**ASHLAND PLANNING COMMISSION  
HEARINGS BOARD  
AGENDA  
SEPTEMBER 9, 2008  
Hearings Board Members: Morris, Dawkins, Stromberg**

**ASHLAND PLANNING DEPARTMENT  
STAFF REPORT  
Addendum  
September 9, 2008**

**PLANNING ACTION:** 2008-00801

**REQUEST:** Request for a Conditional Use Permit and Site Review approval to construct a new 592 square foot Accessory Residential Unit above a proposed two-vehicle garage accessed from the alley for the property located at 960 Harmony Lane.

# ALTERNATE EAST EXTERIOR ELEVATION

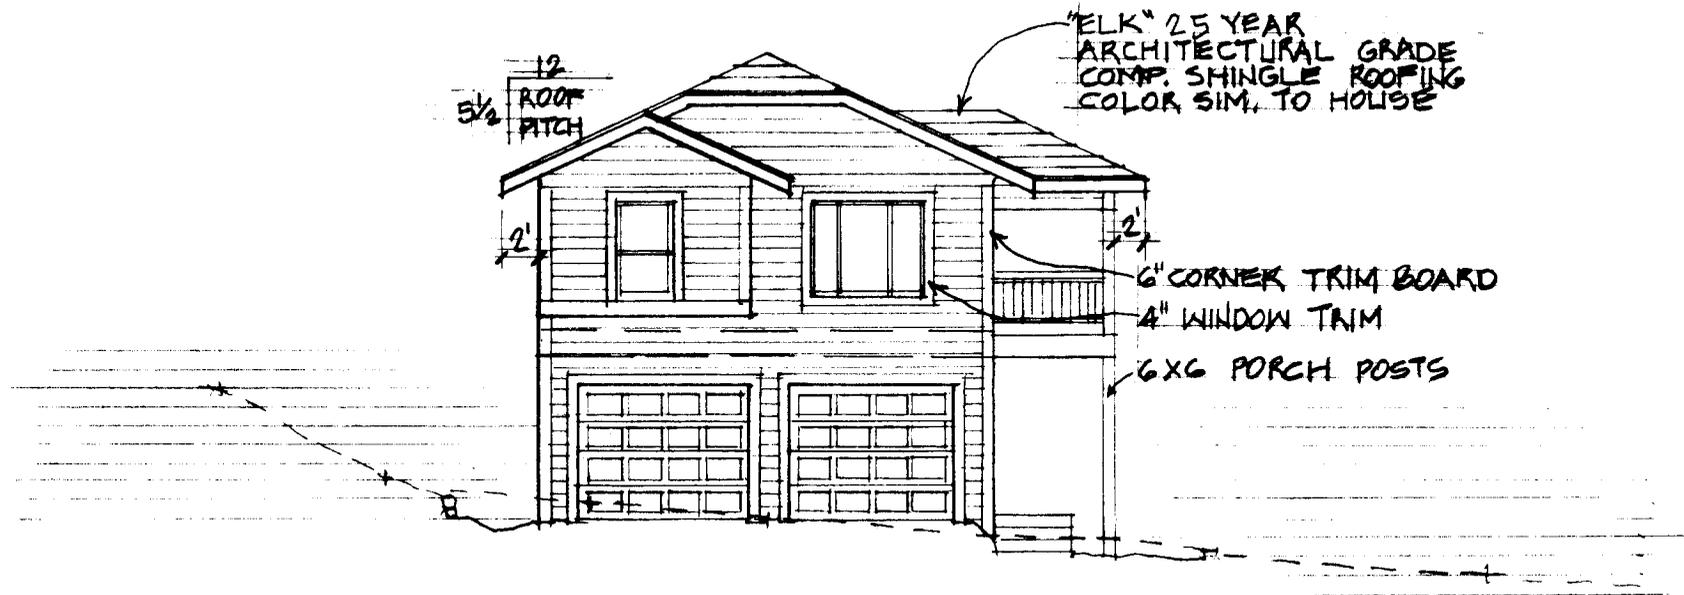
10.104.050. C.3: Please see the Alternate East Exterior Elevation for the Proposed Exterior design.
